Access Compliance Report

Public Rights-of-Way

(Curb Ramps)

Intersection ID: 14659	Main Street: E_WORTHINGTON_AV	Cross Street: SPRINGDALE_AV	Location: W
ADA ID: A68B34B01722	Ramp Type: Perp	Initial Pass/Fail: Fail	Overall Compliance: No
Severity Score: 13.75			
Codes/Mitigation Info/Possible Solution		Field Measurements/Component Compliance

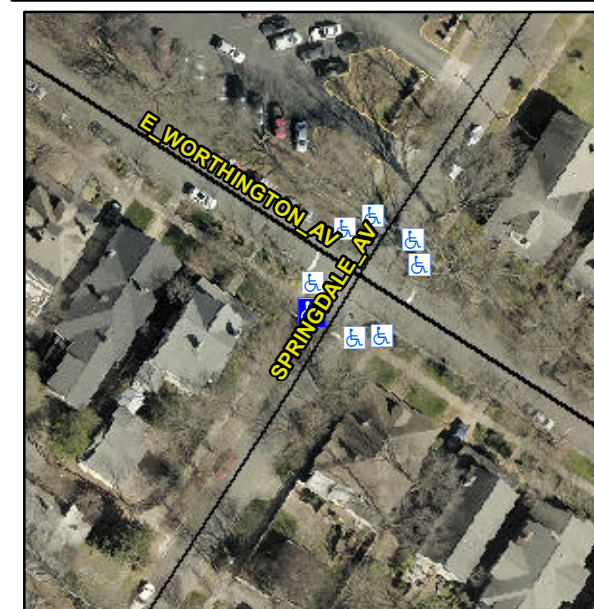
R304.2.2, R304.5.3

Compliance	Description	Data	Compliance	Description	Data
N/A	Ramp Length (in)	108.0	No	Ramp Slope (%)	8.8
Yes	Ramp Width (in)	54.0	No	Ramp XSlope (%)	2.9
N/A	Flare Type LT	N/A	N/A	Flare Type RT	N/A
N/A	Flare Slope LT (%)	N/A	N/A	Flare Slope RT (%)	N/A
N/A	Flare Traversable LT?	N/A	N/A	Flare Traversable RT?	N/A
N/A	Landing Length (in)	N/A	N/A	DWS Provided?	N/A
N/A	Landing Width (in)	N/A	N/A	DWS Contrast?	N/A
N/A	Landing Slope (%)	N/A	N/A	DWS Length (in)	N/A
N/A	Landing X Slope (%)	N/A	N/A	DWS Full Width?	N/A
N/A	Landing Curb? (Y/N)	N/A	N/A	DWS Offset (in)	N/A
N/A	Shared Landing?	N/A			
N/A	Gutter Ponding?	N/A	N/A	Gutter Slope (%)	N/A
N/A	Gutter Lip Ht (in)	N/A	N/A	Gutter X Slope (%)	N/A
N/A	Painted X Walk1?	No	N/A	Painted X Walk2?	N/A
	X Walk 1 Direction	To SE		X Walk 2 Direction	N/A
N/A	X Walk 1 Width (in)	N/A	N/A	X Walk 2 Width (in)	N/A
	X Walk 1 Slope (%)	4.1		X Walk 2 Slope (%)	N/A
	X Walk 1 X Slope (%)	4.0		X Walk 2 X Slope (%)	N/A

Remove & Replace Entire Ramp.
